Access Compliance Report

Public Rights-of-Way

Main Street: **EDINGER_AVE** Cross Street: **HARBOR_BLVD** Location: **SW**

ADA ID: **SGRK220222151356** Signal Type: **One Push Button-Non APS** Overall Compliance: **No** Severity Scores: **BTN 1: 35** **BTN 2: N/A** **No BTN: N/A**

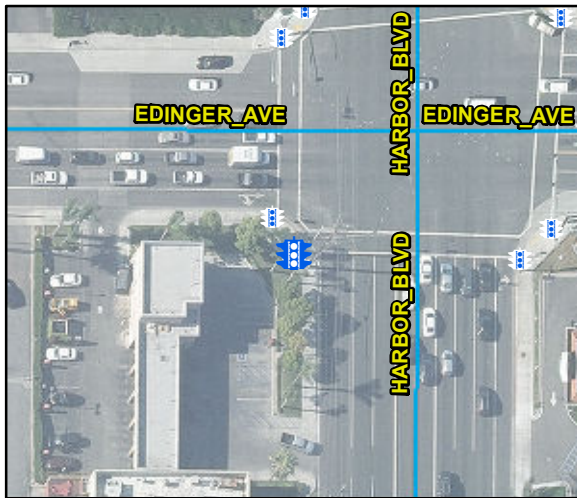
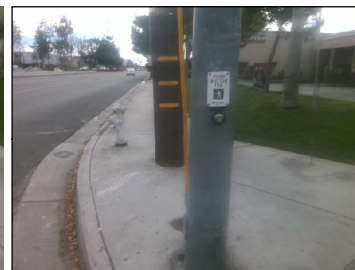
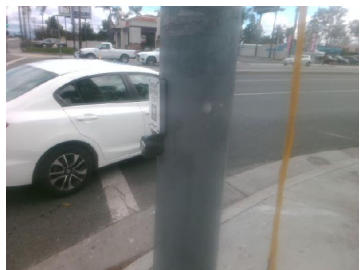
Possible Solutions: Replace Signal Push Button With APS Button. Remove and Replace Clear Space.

OC Std/PROW: **R404.2, MUTCD 4e.08**
